# Technical Service Bulletin

## 34 Oil leak at the transmission connector

34 20 47 2058875/1 March 24, 2020.

**Figure 3.** A thin film of oil in the cavity.

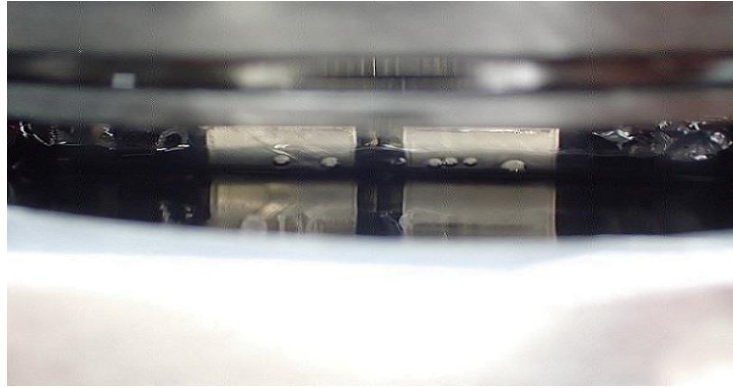
2. Check whether this area has a thin film of oil or if there is an accumulation of oil:
  - Assess the oil leak condition in the indent under the dust cover. This is easily viewable with a flashlight and a mirror.
  - If there is a thin film of oil in the cavity (Figure 3) proceed to Step 2.
  - If there is a puddle of oil in the cavity (a millimeter or more) proceed to Step 4 (Figure 4).

3. Repair/Diagnosis steps for a thin film of oil in the cavity:
  - *Very thoroughly clean the area* and spray the affected area with oil leak detection spray (Part # G 001 900 A1 or a locally available talcum based oil leak detection spray equivalent).

- Perform an extensive test drive and assess the oil in the cavity again.
  - If there is no more oil accumulation, it is not necessary to fit a new seal. No further repair is required and the repair is complete. The film of oil was most likely from the assembly of the transmission.

**Figure 5.** Option for 2<sup>nd</sup> seal.

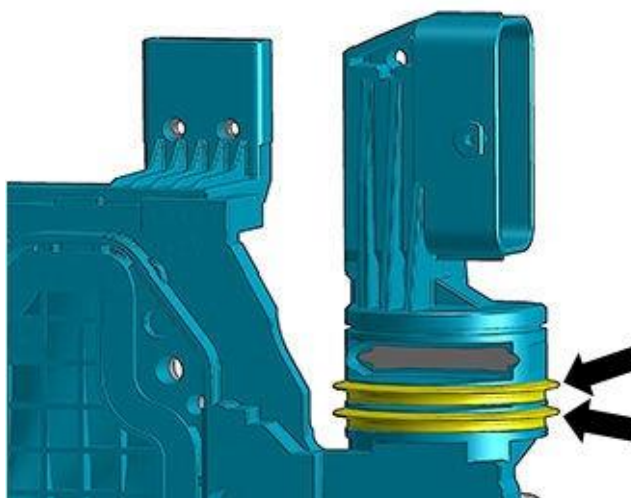
- When the transmission was manufactured, a single seal was installed on the transmission control unit but there is an option for a second lower seal (Figure 5). To repair the oil leak we will replace the original seal and add a second seal in the lower position (Figure 6).

- Remove the mechatronics unit per the repair manual.
- Remove the original seal from the transmission control module.
- Install two new seals with the sealing lip on the side of the electrical connection (Figure 7).
- Reinstall the mechatronics unit per the repair manual.
- Clear any faults that may have been set during the repair.
- Test drive and confirm the leak is repaired.
